City of Phoenix
PLANNING AND DEVELOPMENT DEPARTMENT

To: City of Phoenix Planning Commission **Date:** November 7, 2019

Subject: ITEM NO. 11 (Z-36-19-6) – NORTHWEST CORNER OF 44th STREET AND CAMELBACK ROAD

CAMELBACK ROAD - SOUTHEAST CORNER

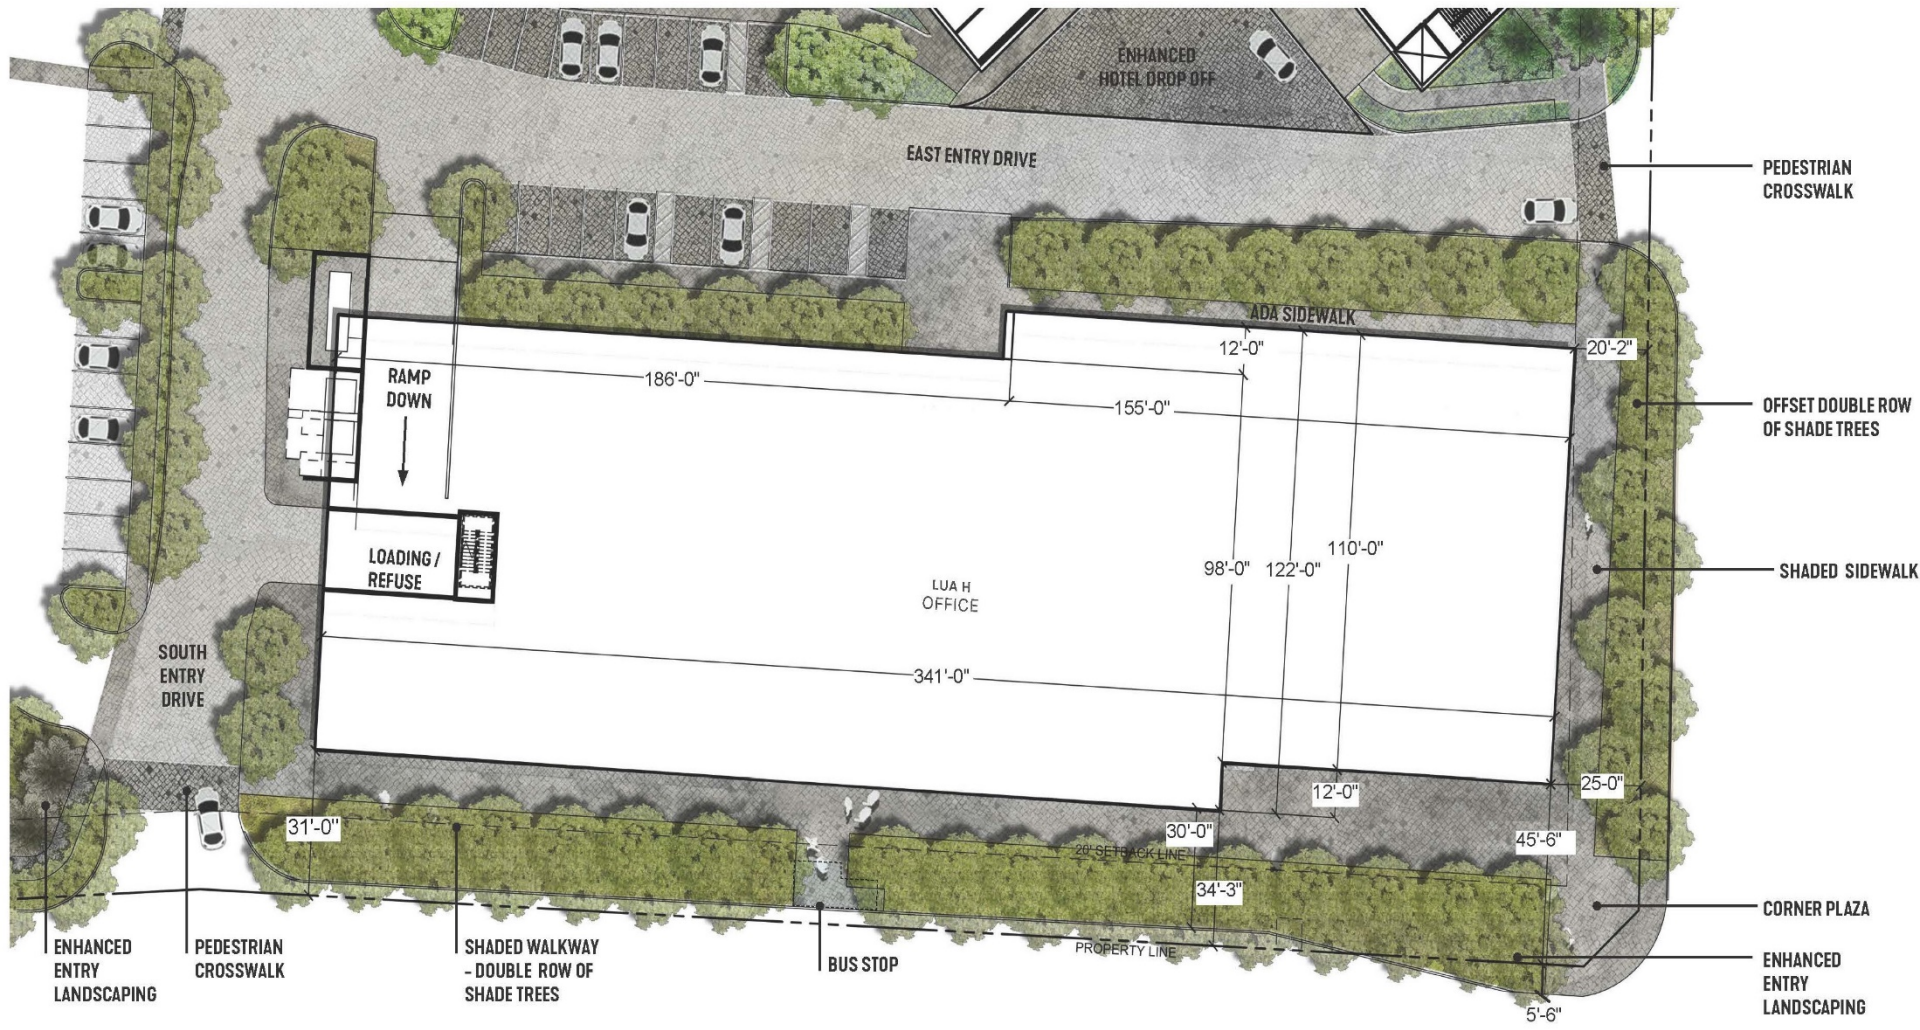
- k. **PAGE 20, BUILDING SETBACKS, SOUTH AND EAST: MODIFY AS FOLLOWS:**

<p>Building Setbacks *See Building Setback Exhibits at Exhibit 9</p>	<p>South:</p> <p><u>Land Use Area G</u> 20 feet Minimum</p> <p><u>Land Use Area H</u> 30 feet minimum for a minimum of 264 linear feet and 45 feet minimum for a minimum of 115 linear feet along LUA H</p> <p>East:</p> <p>20 feet minimum, except 25 feet minimum within 45 feet of the southern property line</p>
--	--

- ~~10. THE MINIMUM SETBACKS ON THE SOUTH AND EAST SIDE OF THE OFFICE BUILDING ON THE 44TH STREET AND CAMELBACK CORNER, INCLUDING THE ADDITIONAL SETBACK FOR THE SOUTH EAST CORNER OF THE OFFICE BUILDING SHALL BE AS DEPICTED ON THE UPDATED SITE PLAN SHOWN TONIGHT.~~

- m. **EXHIBIT 9: ADD SETBACK EXHIBIT IDENTIFYING THE DIMENSION FOR THE SOUTHERN AND EASTERN BUILDING SETBACKS FOR LAND USE AREA H.**
2. There shall be no access to 42nd Place and 43rd Place and the developer shall record a 1-foot non-vehicular access easement along all parcel lines adjacent to single-family zoning district or local street, **EXCEPT FOR AN APPROXIMATELY 30-FOOT WIDE GATED VEHICULAR ACCESS AND AN APPROXIMATELY 6-FOOT WIDE GATED PEDESTRIAN ACCESS LOCATED APPROXIMATELY 40 FEET NORTH OF CAMELBACK ROAD THAT SHALL BE ALLOWED BETWEEN THE SUBJECT PROPERTY AND THE MEDLOCK DRIVE ALIGNMENT WITHIN ARCADIA VILLA 2**, as approved by the Planning and Development Department.
